## REMARKS

This is intended as a full and complete response to the Office Action dated August 30, 2005, having a shortened statutory period for response set to expire on November 30, 2005. Please reconsider the claims pending in the application for reasons discussed below.

FIG. 3

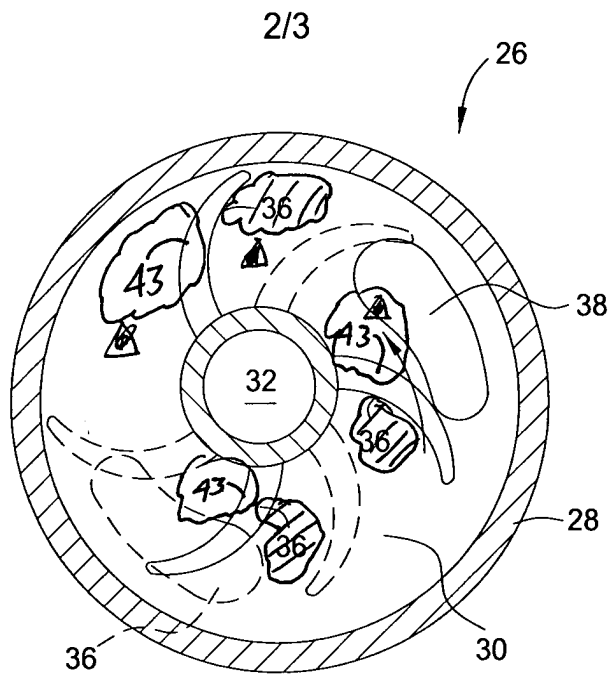
The drawings are objected to as failing to comply with 37 C.F.R. § 1.84(p)(4) because reference character "36" has been used to designate both an outlet and a vane

(see Fig.3). Figure 3 has been amended to show the vanes or blades as 43. Having corrected the drawing, Applicant respectfully requests withdrawal of the objections to the Figures.

In amended Figure 3, previously labeled element 36 has been changed to 43. In amended Figure 4 the previously omitted element numeral 98 has been added.

FIG. 2

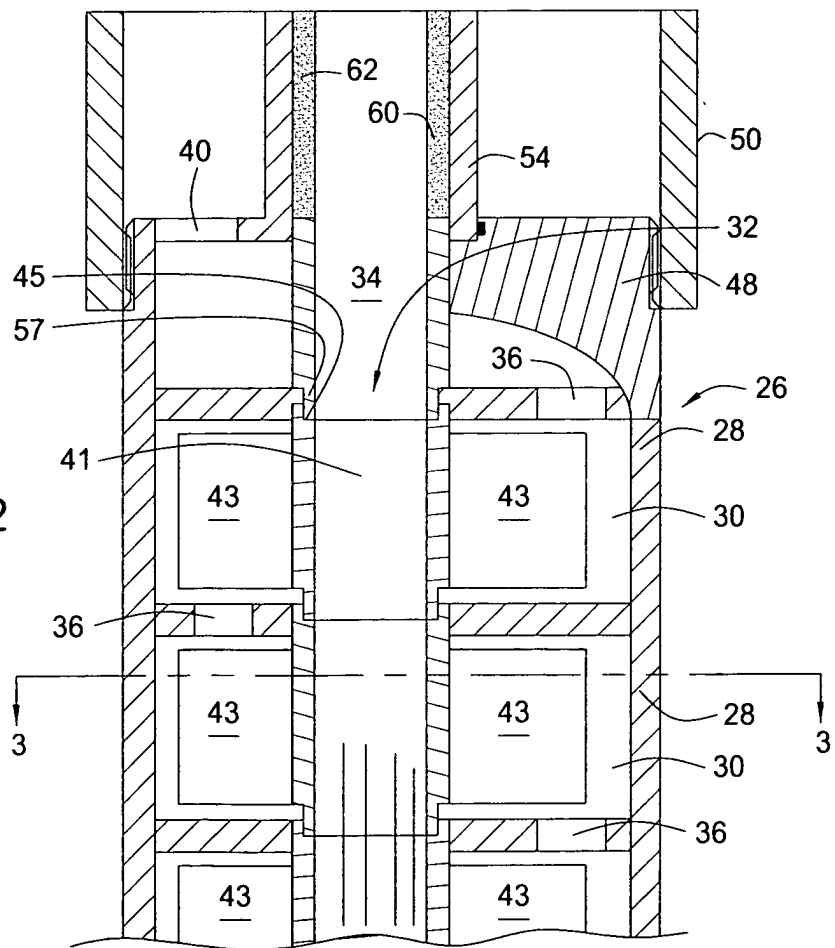
In addition, it is stated in paragraph [0021] that the uppermost outlet of the pump is sealingly engaged and in fluid communication with the inner circumference of sleeve 54. Analysis of Figure 2 leads one to believe that the outlet 40 is in communication with the annulus defined by tubing 50 and sleeve 54. It appears that if the outlet were to be in communication with the inner circumference of sleeve 54, then the system would fail because either the produced fluids would not be able to exit or the dampening capabilities would be diminished or destroyed. Applicant has corrected paragraph [0022] so that the outlet 40 is ported to the tube 50, therefore Applicant respectfully request removal of the objection.

The attached sheet of drawings includes changes to Fig. 2. This sheet, which includes Figs. 1-2, replaces the original sheet including Figs. 1-2. In Figure 2, previously omitted element 13 has been added.

FIG. 4

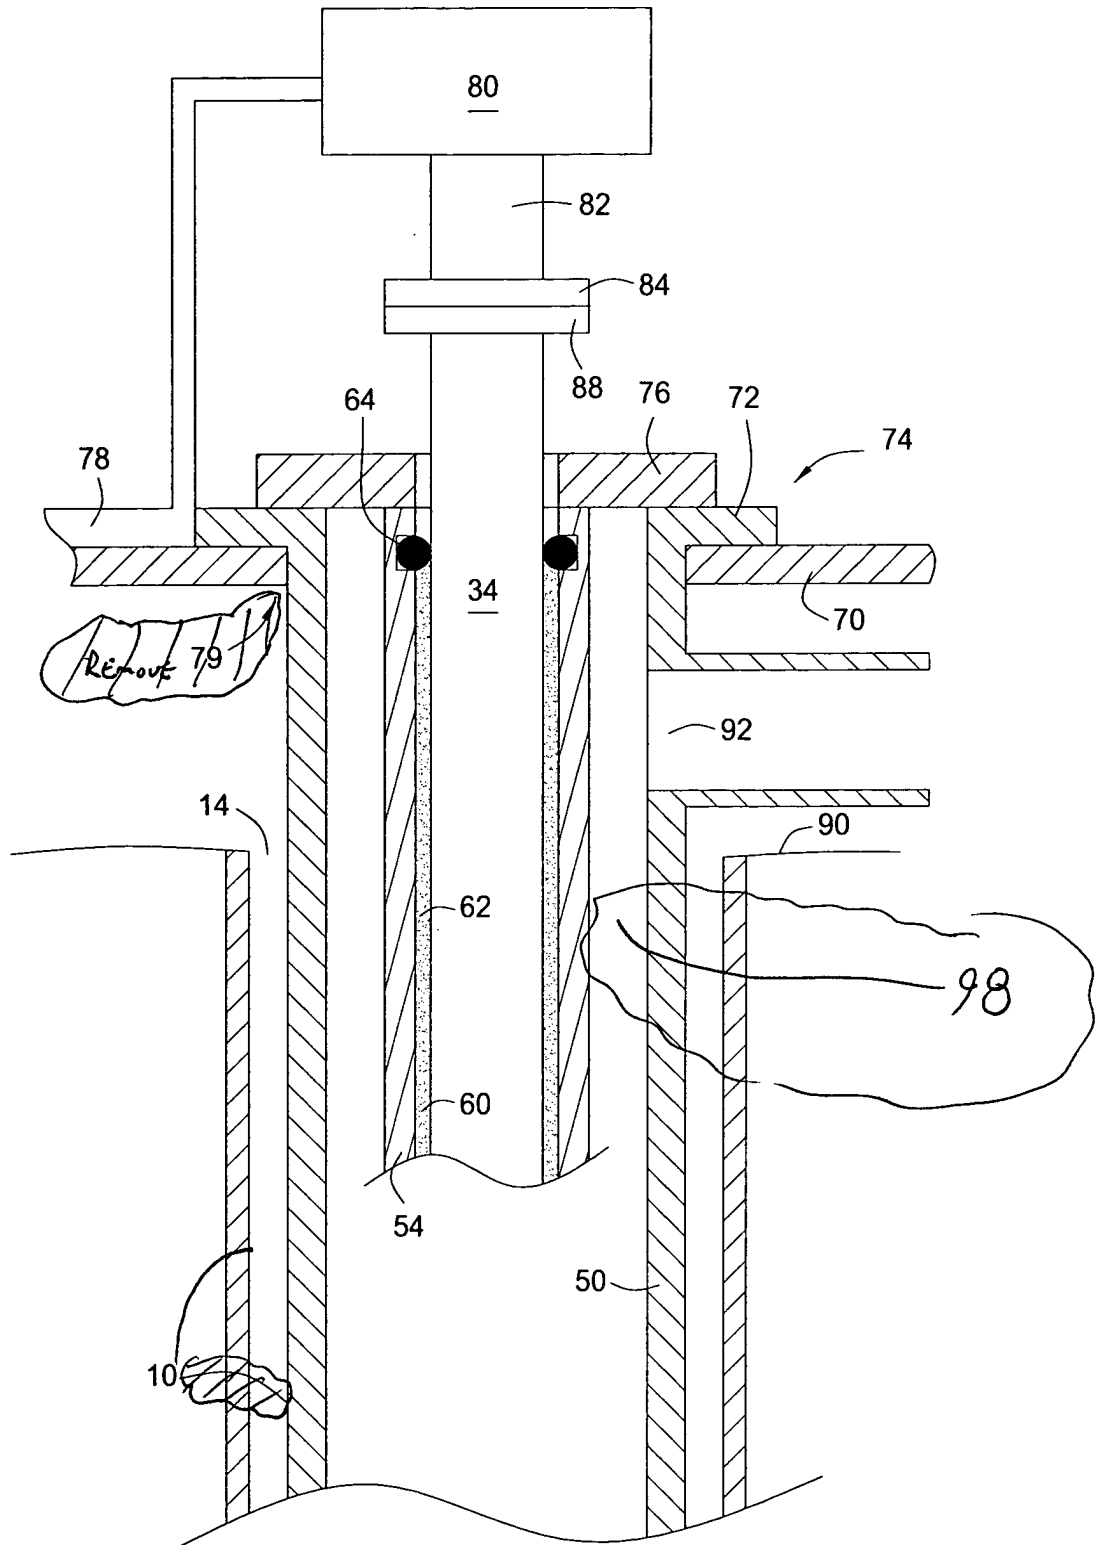
The drawings are objected to as failing to comply with 37 C.F.R. § 1.84(p)(5) because they do not include the following reference sign(s) mentioned in the description: 22, 58, and 98.

The drawings are objected to as failing to comply with 37 C.F.R. § 1.84(p)(5) because they include the following reference character(s) not mentioned in the description: 79. Applicant has removed element 79 from Figure 4.

Reference number 98 has been added to Figure 4, and 79 has been removed.
